**CITY OF BATON ROUGE
PARISH OF EAST BATON ROUGE**

ADDENDUM NO.2

**SUBJECT: Port Hickey Rd. Bridge over Drainage Bayou
(RECALL NO. 800498)**

CITY PARISH PROJECT NO. 16-BR-PT-0019

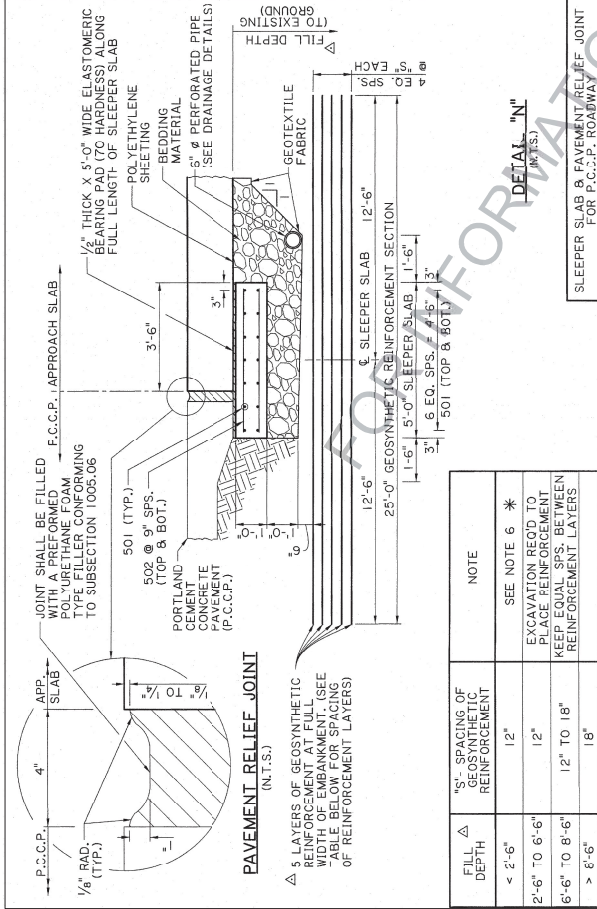
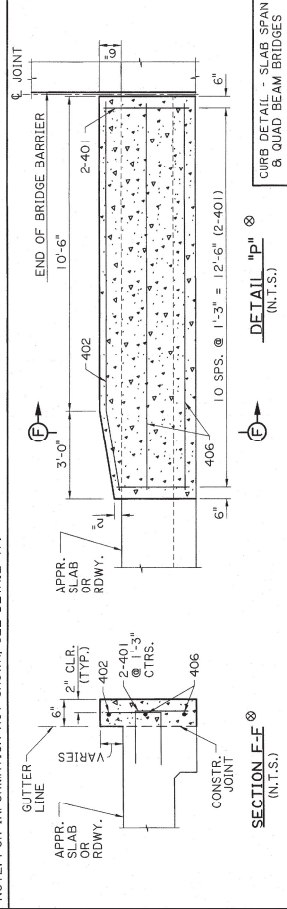
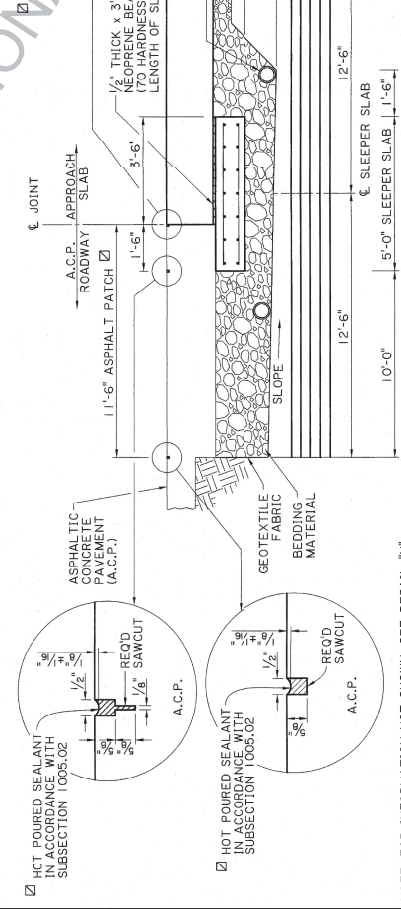
What is sleeper slab and bedding material thicknesses under approach slabs?

For information only, refer to attachment of this addendum for the thicknesses. Official LaDOTD approach slab standard details will be provided at pre-construction meeting.
